City Planning Commission
Sacramento, California

Subject: A. Negative Declaration
B. Special Permit Time extension to develop six "petite homes" and one halfplex in the Single Family Alternative (R-1A) zone.

Location: 2840 Taft Street

EXHIBIT A-2
SITE PLAN

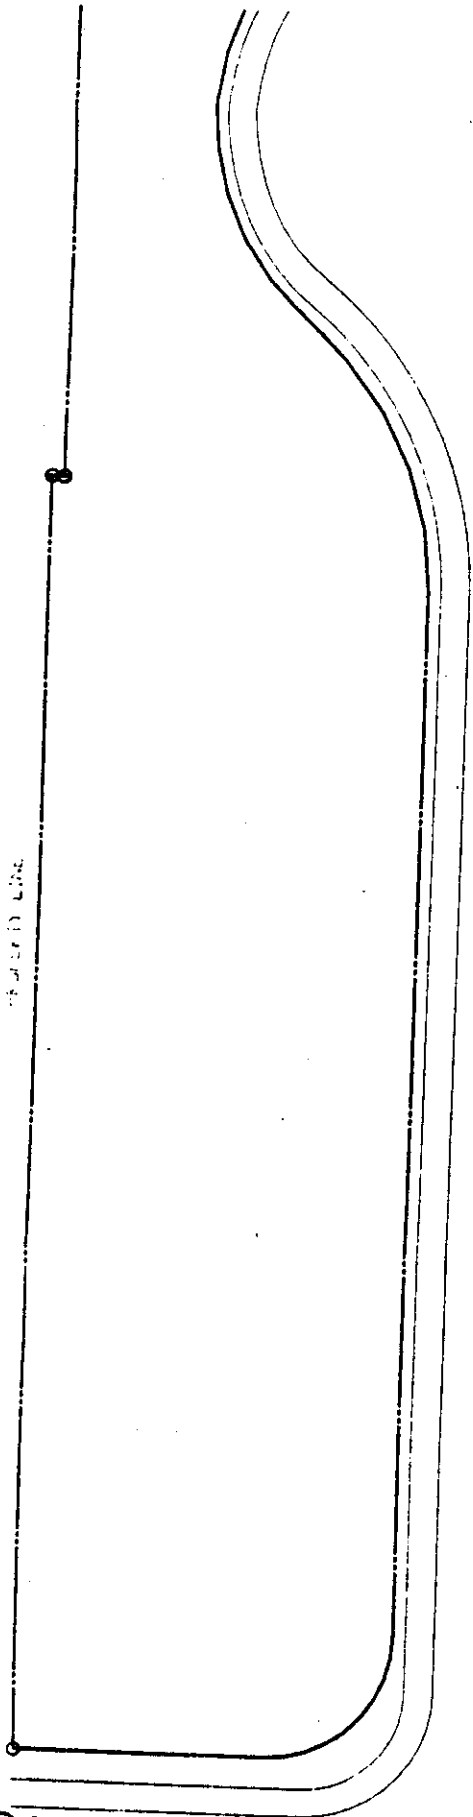
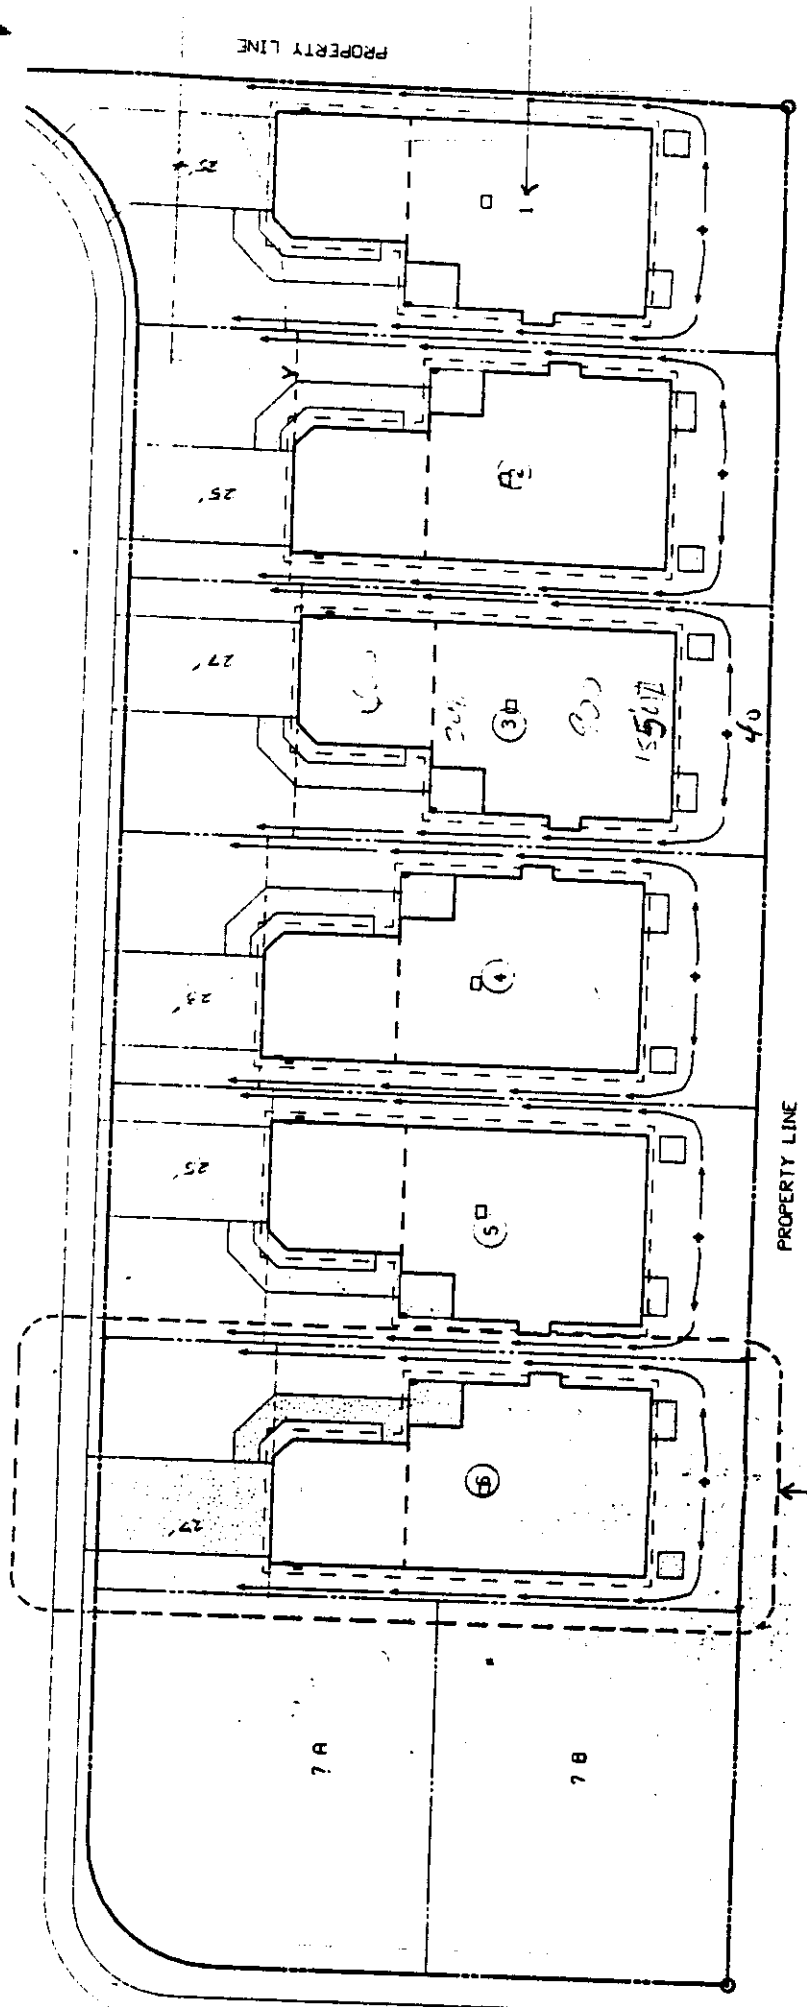
The applicant has submitted a site plan depicting variable setbacks for the six single family homes previously approved and the corner lot halfplex unit. The halfplex plans indicate an 18 foot front yard building setback and driveway depth (front and side street driveways). The minimum required driveway depth for residential development is 20 feet. A five foot setback is proposed along the south property line and seven feet seven inches is proposed along the east property line which will not provide an adequate usable rear yard area for the units. Staff recommends the site plan for the halfplex lot be redesigned to meet driveway, setback and lot coverage requirements prior to issuance of building permit for the unit.

9. A revised site plan for the halfplex lot shall be reviewed and approved by the Planning Director prior to issuance of building permits. The plans shall indicate 40% lot coverage, minimum 20 foot front yard setback, 12.6 foot side yard setback and adequate useable rear yard area. The rear yard area shall be determined by a 15 foot rear yard or rear yard substitution as allowed by the Zoning

Ordinance. Each unit shall have its entrance, including driveways, off different streets. Each driveway shall be a minimum of 20 feet in depth.

EXHIBIT D

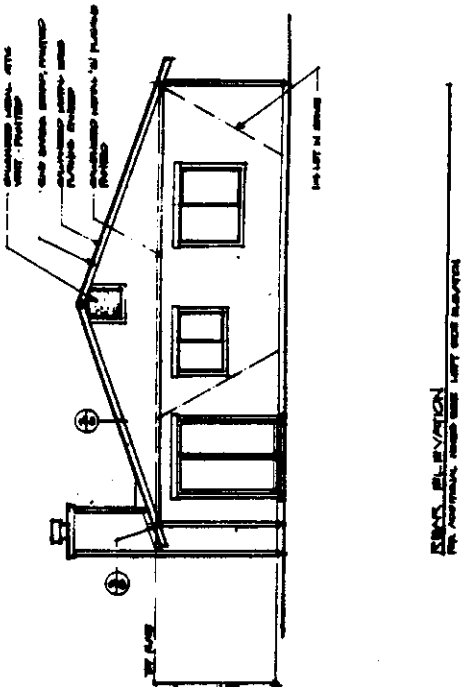
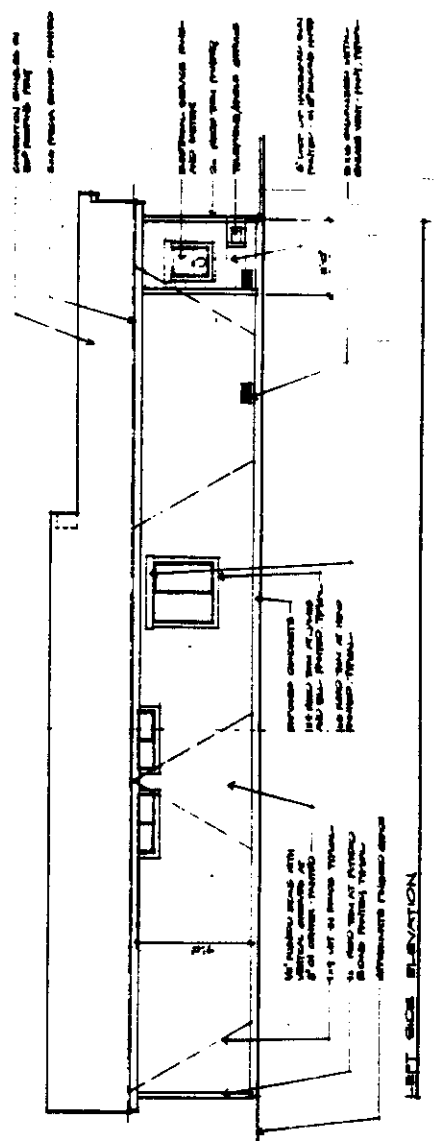
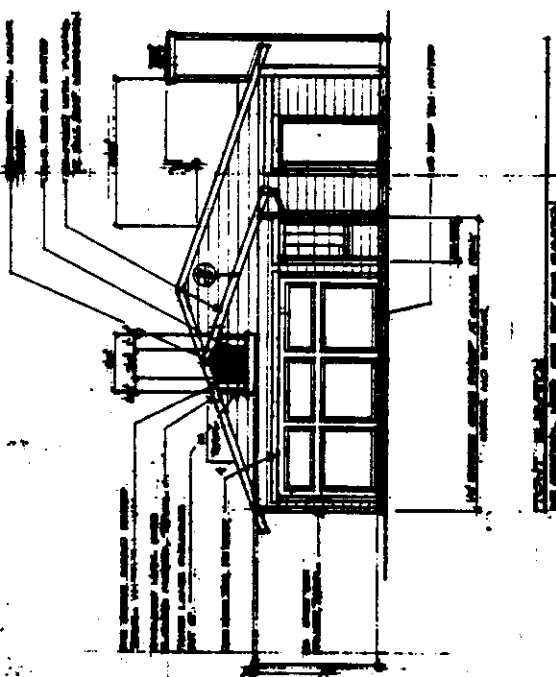
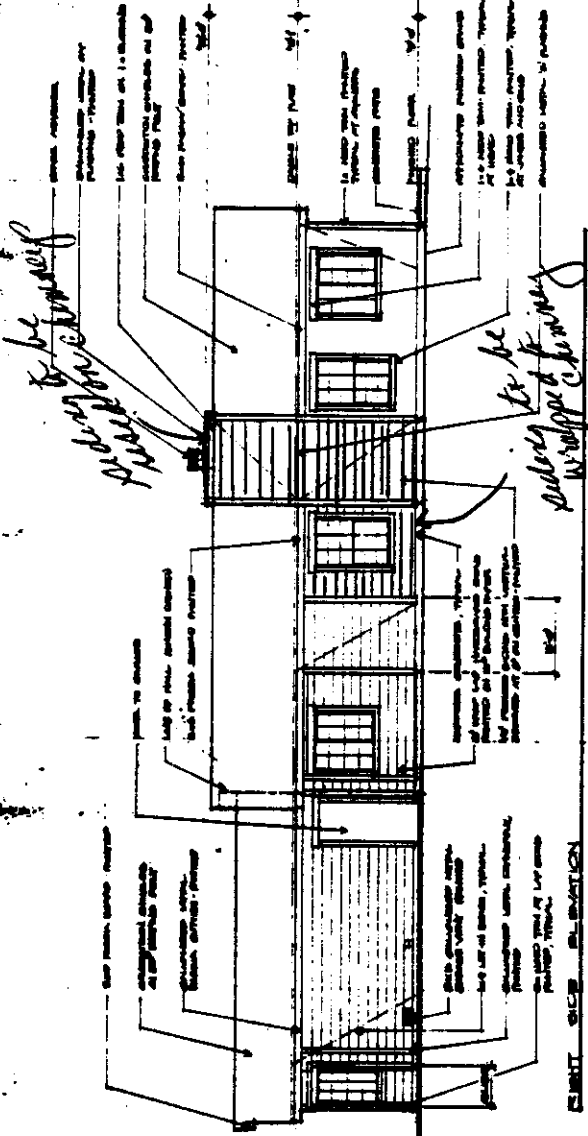
3. The masonite horizontal lap siding should be wrapped on the right side elevation to the chimney (Exhibit D).
4. The applicant should use the masonite horizontal lap siding on the three sides (north, east and west) of the chimneys (Exhibit D).

3. The masonite horizontal lap siding shall be wrapped on the right side elevation to the chimney.
4. The applicant shall use the masonite horizontal lap siding on the three sides (north, east and west) of the chimneys.

STAFF EXHIBIT

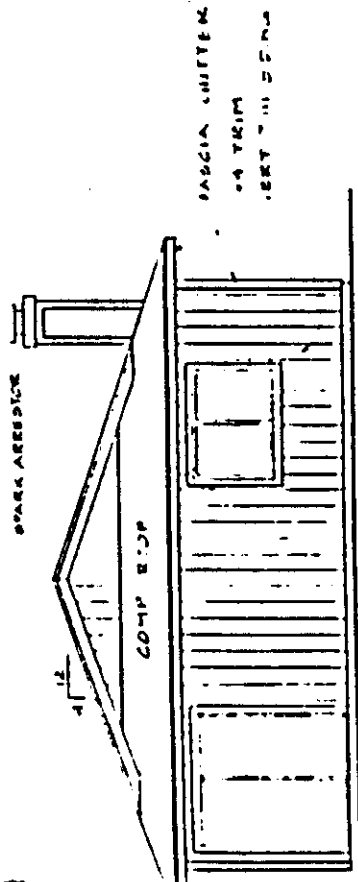
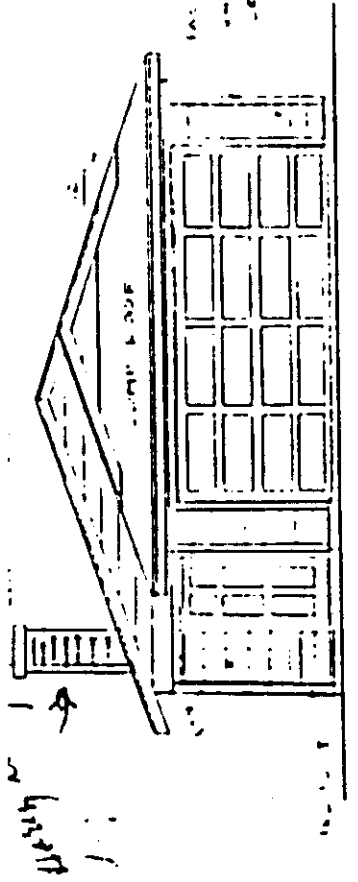
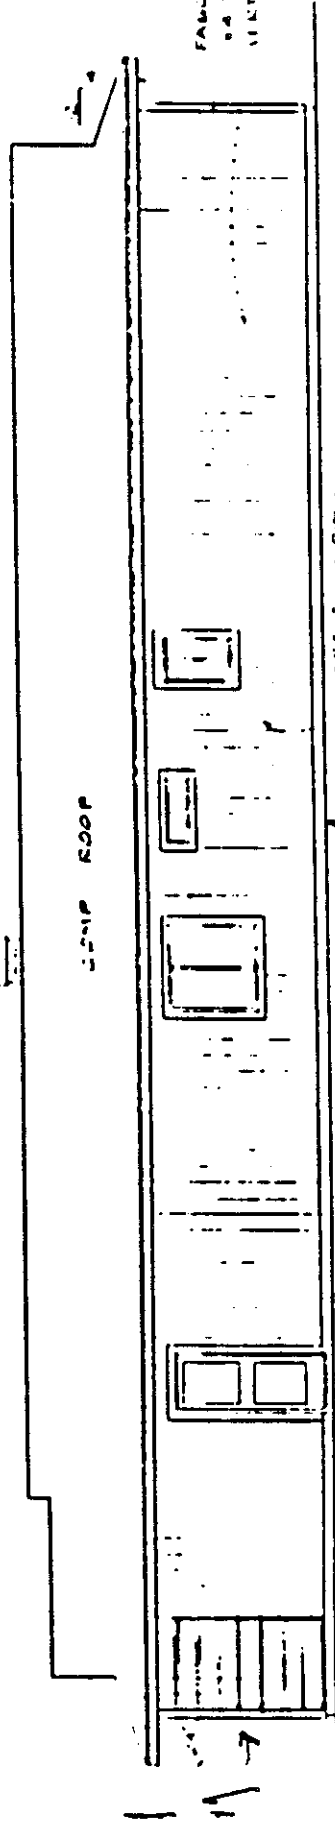
5. In order to provide some variation in the elevations of the six units, staff recommends alternating the roof lines of the garages with a gable (Exhibit B) and a dutch gable (Exhibit E). To provide further variation staff recommends utilizing four inch, six inch and eight inch siding. Two units should be constructed with four inch siding, two units with six inch siding and two units with eight inch siding.

5. The applicant shall utilize a gable or dutch gable roof line on the garages of every other unit.
6. The applicant shall utilize four inch, six inch and eight inch siding on the units. Two units shall be constructed with four inch siding, two units with six inch siding and two units with eight inch siding.

UNIT E STAFF MODIFIED ELEVATIONS

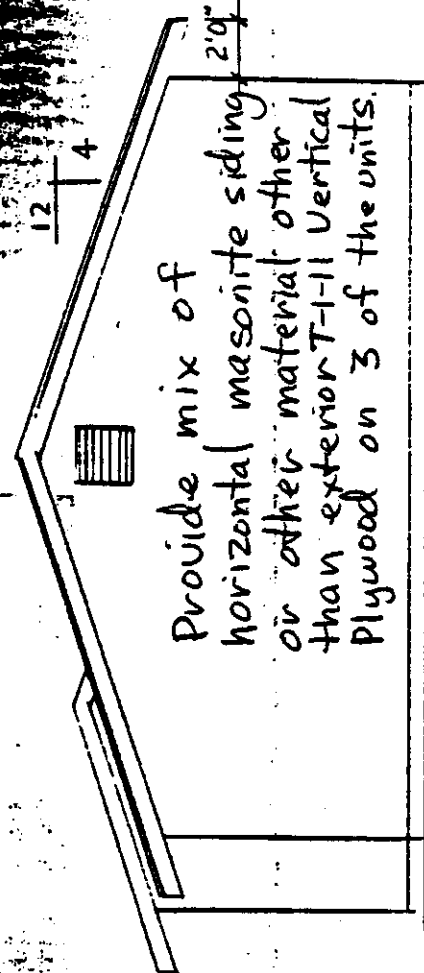
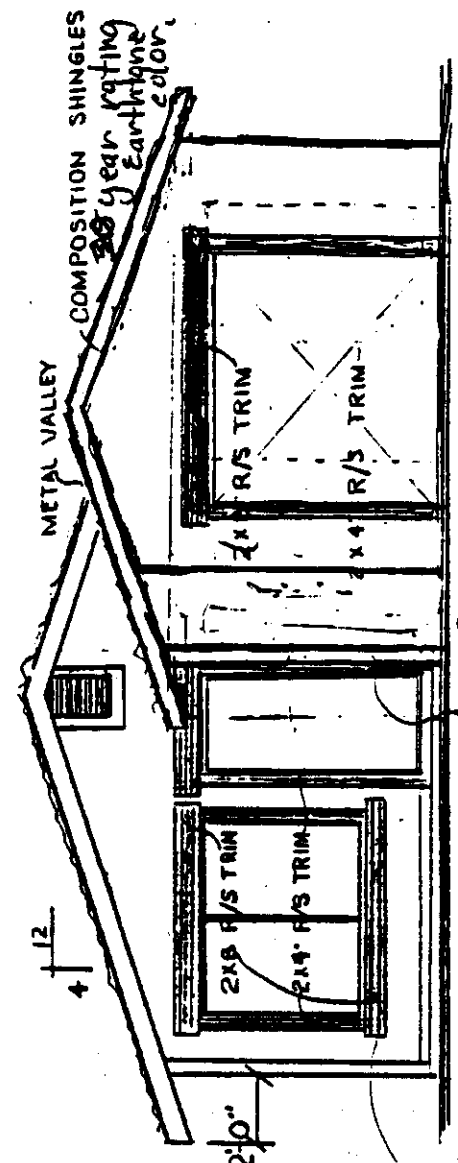
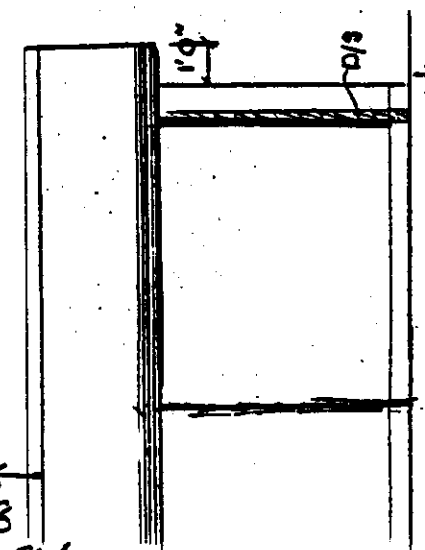
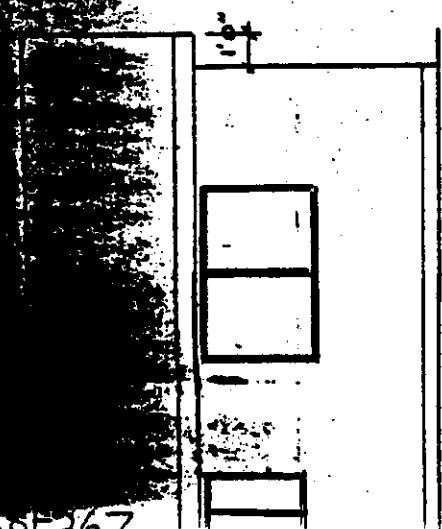
1. The garage should be moved three feet to the side to increase the building's width to 30 feet. With the increased width, three feet can be added to the area between the garage and entry way. Staff recommends decorative trim or lattice elements to be added to break up the elevation as viewed from the street.

Increase distance by 3ft from Garage to main entrance.

1. The applicant shall revise the building elevations to show a dwelling with three additional feet of width between the entrance and garage as shown on the staff modified front elevation for a total building width of 30 feet. A decorative trim lattice or similar element is to be shown to provide variety to the front elevation.
